Subject: REAR PARKING SENSOR BEEPS WITHOUT ANY OBSTACLE BEHIND VEHICLE WHEN REAR USB POWER OUTLET IS BROKEN	Bulletin No.: 09-033/19
	Last Issued: 08/16/2019

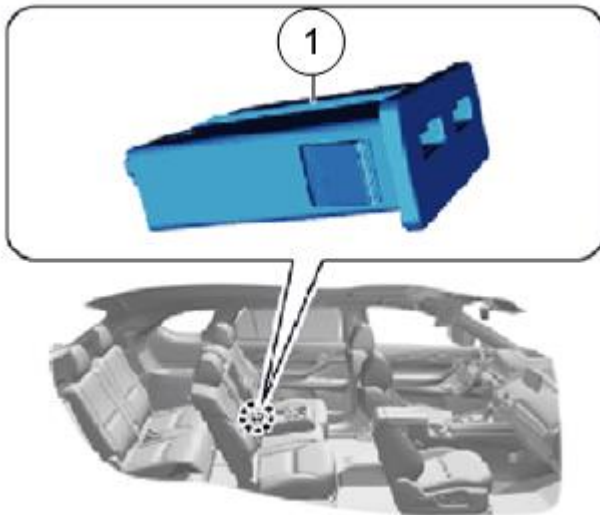
Some vehicles may exhibit the rear parking sensor beeping without any obstacles behind it when the shift lever is shifted into Reverse. This concern only occurs when the rear USB power outlet (1) is broken. This is caused by noise from USB interference with the harness of the rear parking sensor (when the USB power outlet is broken).

To correct this issue, the configuration of the USB power outlet has been changed to improve durability.

- YES: Go to next step.
 - NO: This TSB does not apply.
6. Replace the USB power outlet with a modified one according to the instructions on MGSS.
 - Mazda6 (USB POWER OUTLET REMOVAL/INSTALLATION)
